**Report on the reliability performance
of
Aurora Energy Limited**

**Produced for
The Commerce Commission**

24 June 2013

This report has been prepared to assist the Commerce Commission with its assessment of the quality performance of the Aurora Energy electricity distribution network.

Figure 2 - Worst performing feeders SAIDI

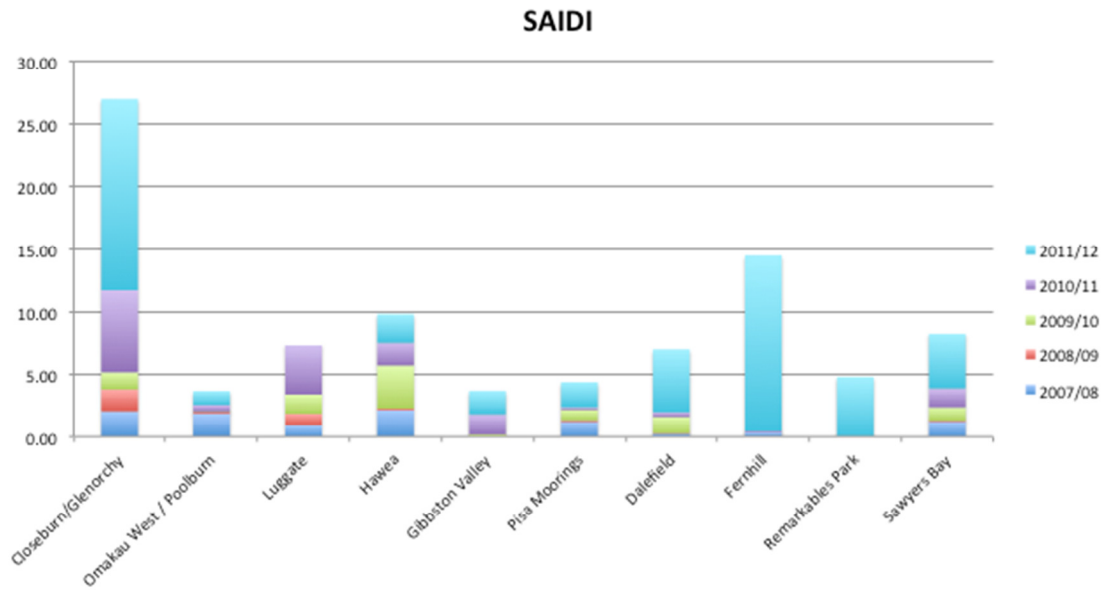
37 In this section we make a number of observations in relation to Aurora's performance against SAIDI and SAIFI limits. In relation to SAIDI performance, the 10 worst performing feeders can be seen to include the more remote and exposed 11 kV feeders. Figure 2 shows the impact of the 2010/11 and 2011/12 years on the long rural feeder to Glenorchy at the head of Lake Wakatipu.

Figure 3 - Worst performing feeders SAIFI

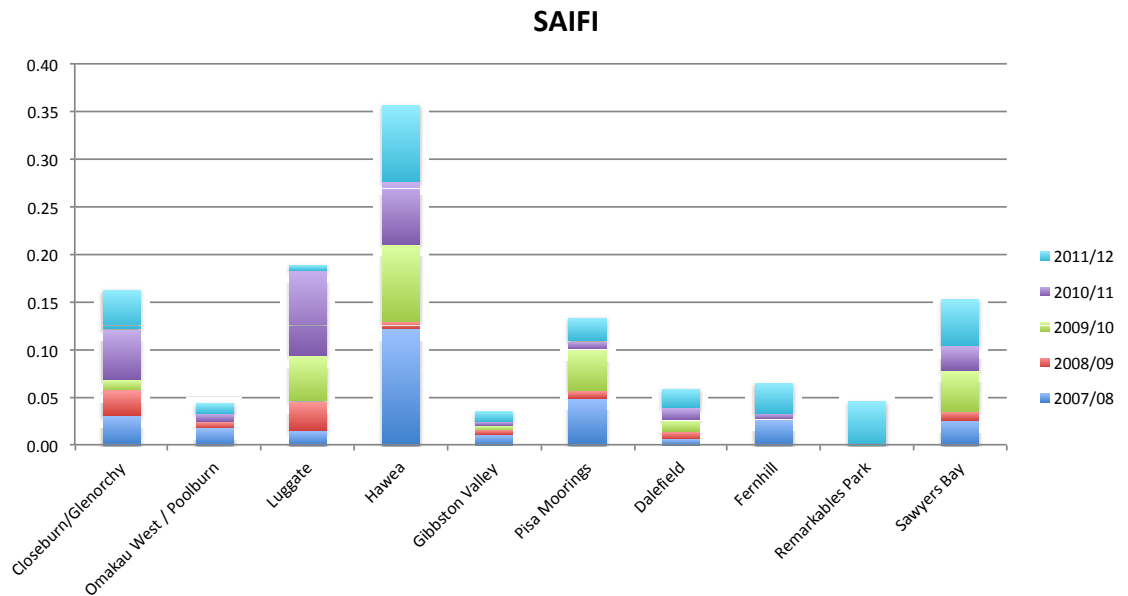
38 The top ten worst performing feeders in respect of SAIFI are generally the same as those for SAIDI. It is also apparent that the SAIFI performance has been deteriorating over the longer term for these feeders, which suggests that outage incidence has been increasing.

Figure 4 - Reliability targeted expenditure

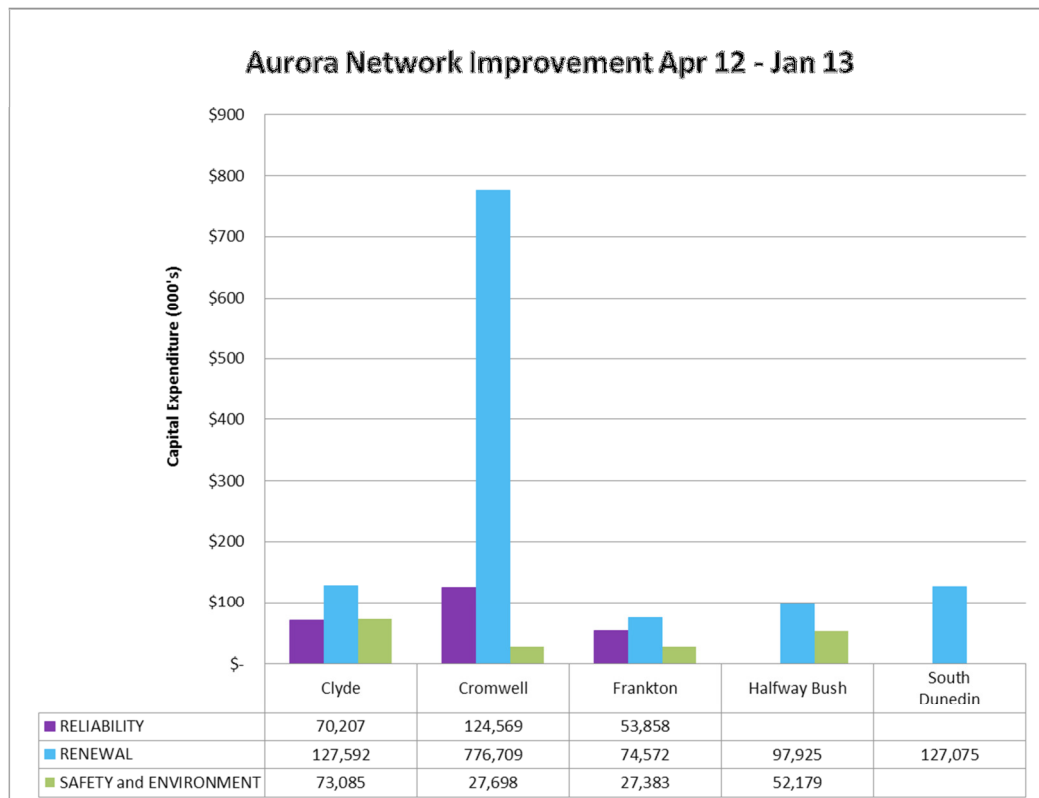
54 It can be seen from Figure 4, provided by Aurora, that the business has been targeting the main focus of its reliability improvement expenditure in the Cromwell area. We saw some evidence of this during our on-site inspection of network assets. We also saw evidence of more widespread pole replacement work having been undertaken in the Queenstown (Frankton) area.

Figure 5 - Forecast expenditure

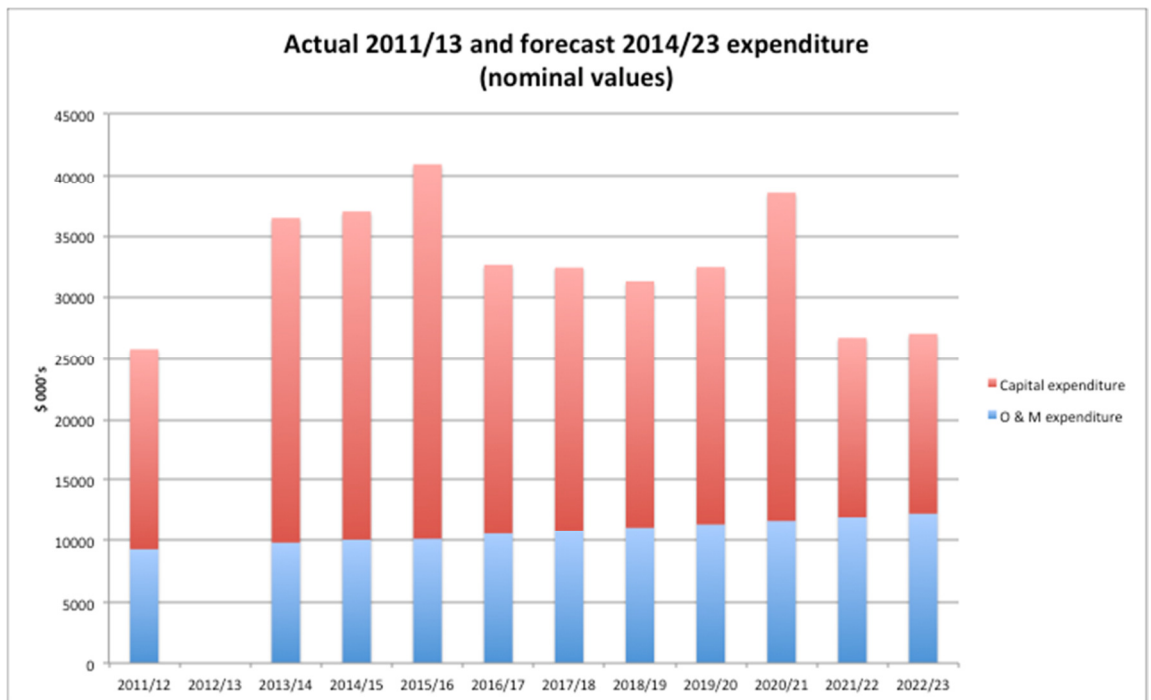
- 56 Figure 5 sets out Aurora’s actual capex and opex for the two years 2011/13 and the forecast expenditure for the following ten years to 2023. The variable expenditure is driven by capex, which is in turn driven by demand growth and the target age and replacement profiles of the network assets.

- 57 The capital expenditure profile shows Aurora’s view of the level of commitment and investment that will be necessary to maintain network performance within required levels.

Figure 8 - O & M expenditure forecast and vegetation management category

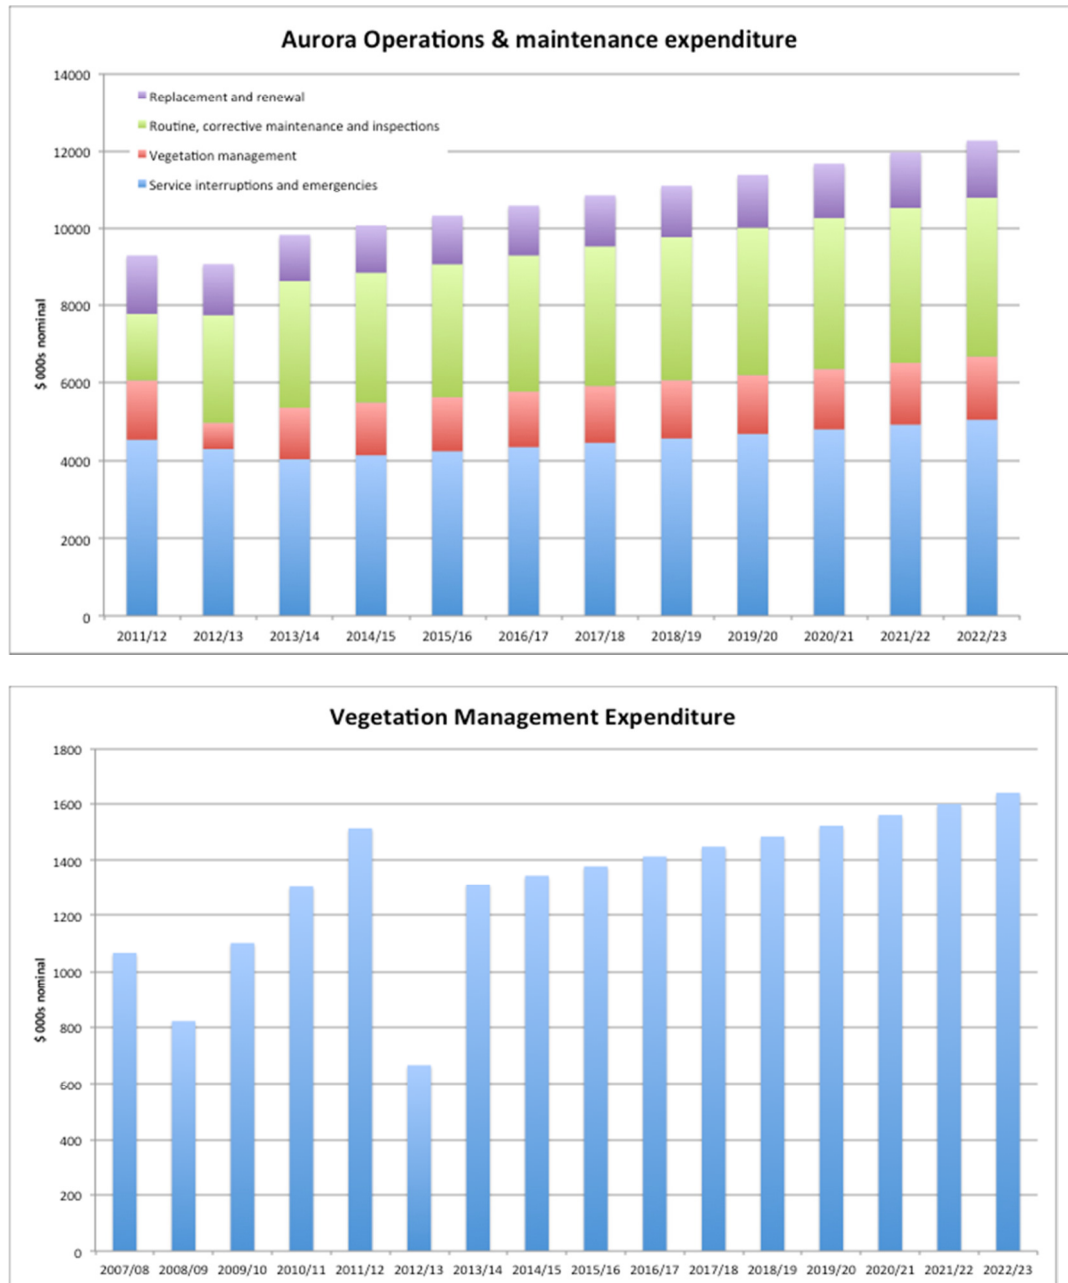
For the ongoing programme, the forecast vegetation management expenditure will remain constant in real terms for the next ten years at 13% of total Operational and Maintenance expenditure (see Figure 8).

Figure 9 - Age profile of 11 and 6.6kV distribution cables

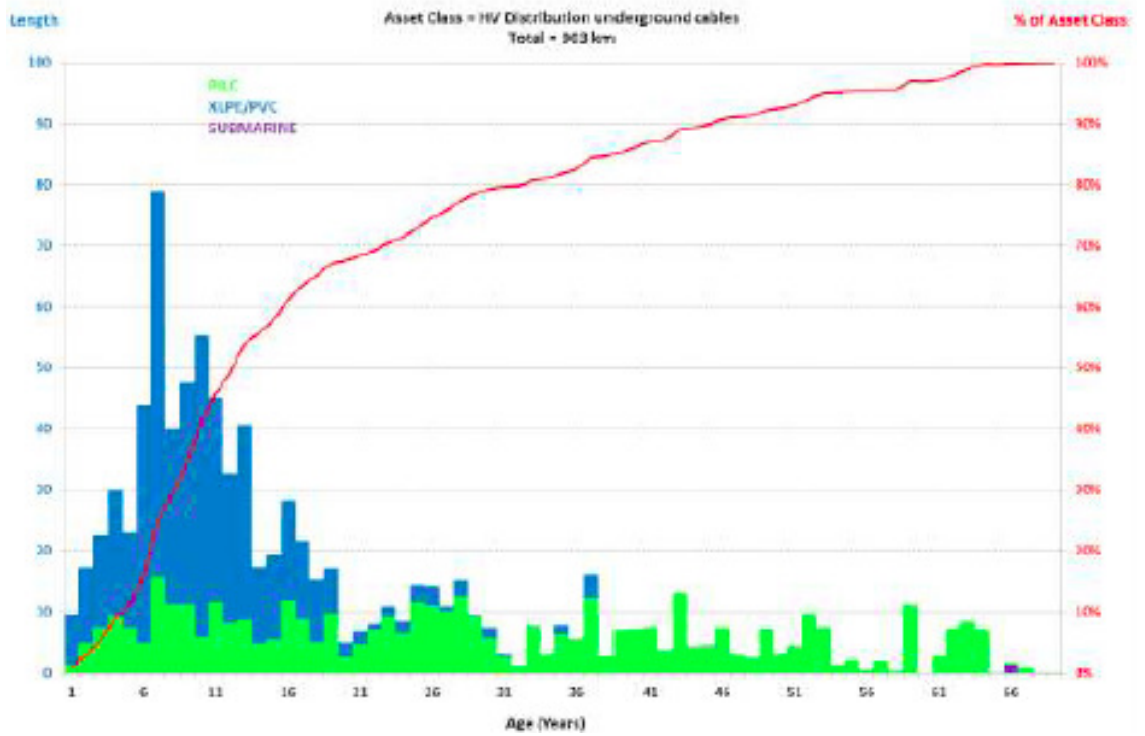
93 Aurora's distribution cables (11 and 6.6 kV) have a relatively young age profile with Aurora experiencing no problems with deterioration to date⁴. Approximately 47% of the distribution cables are PILC and 53% XLPE cables. The XPLE cables generally being under 20 years old.

94 The age profile and condition of the distribution cables are important because Aurora is relying on these assets to support its aging 33 kV subtransmission cables. This is particularly relevant to the security and reliability of electricity supply in Dunedin. The age profile of the 33 kV subtransmission cables is shown in figure 10.

Figure 10 - Age profile 33 kV subtransmission cables

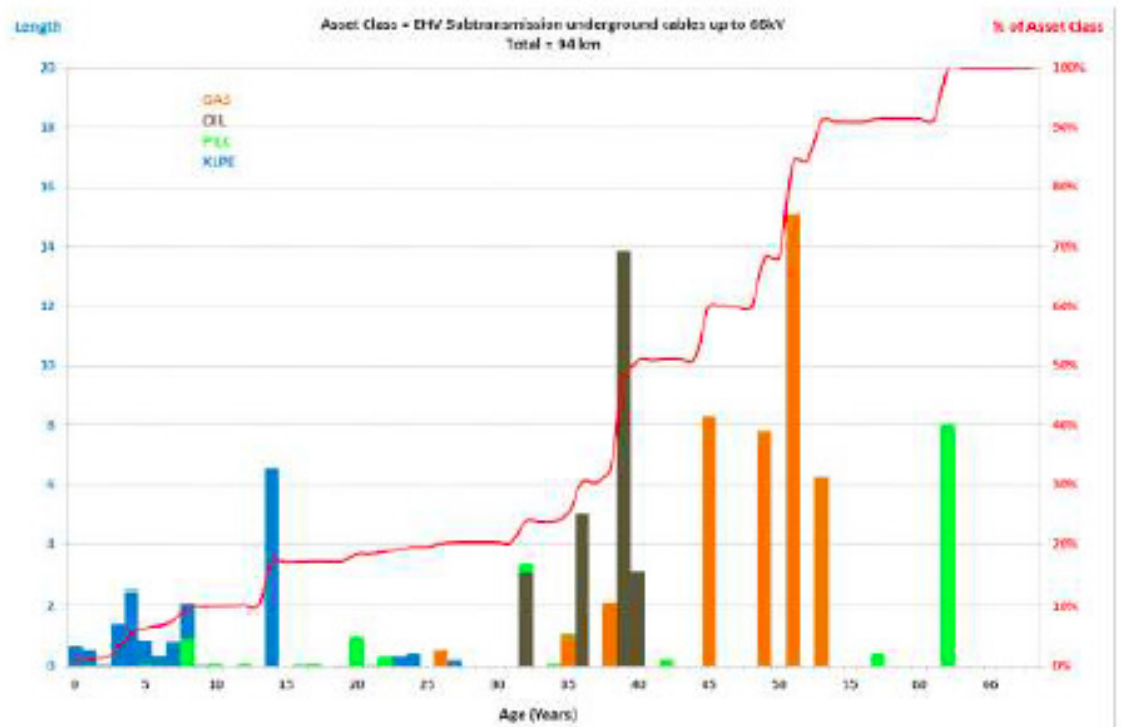
- 95 A key area of focus for Aurora is the gas insulated cables that, at 50 years and above, are at the end of expected life. We questioned Aurora on their strategy for monitoring condition of the cables and contingency management if faults began to occur more frequently. Aurora’s plan is to utilise the switching capability of the 11 kV network to provide alternative supply pathways should 33 kV cable failures occur.

- 96 Aurora’s strategy is appropriate and should provide sufficient backup if sporadic faults occur. However, if failure rates increase significantly and concurrently across a number of cables, system reliability could suffer and the risk of major power outages will increase. Aurora has informed us that it intends to develop a strategy to deal with replacement of the aging 33 kV cables. We consider that the development and implementation of this strategy will be important for the long-term reliability performance of the subtransmission network.

Figure 12 - Network performance SAIDI

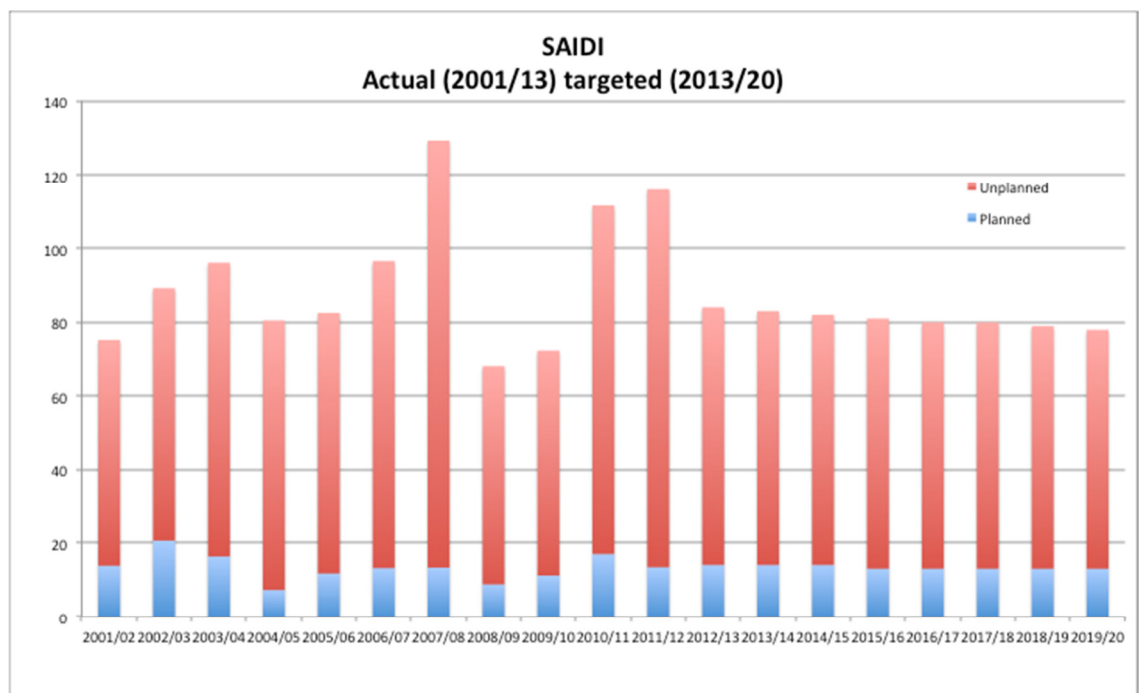
128 It can be seen that network performance in terms of both the average duration and frequency of outages has improved significantly compared with the previous two periods. The improvement is likely to be due in part to the focus and work programme that Aurora has undertaken on the worst performing feeders, also because the increased vegetation management programme is beginning to show results.
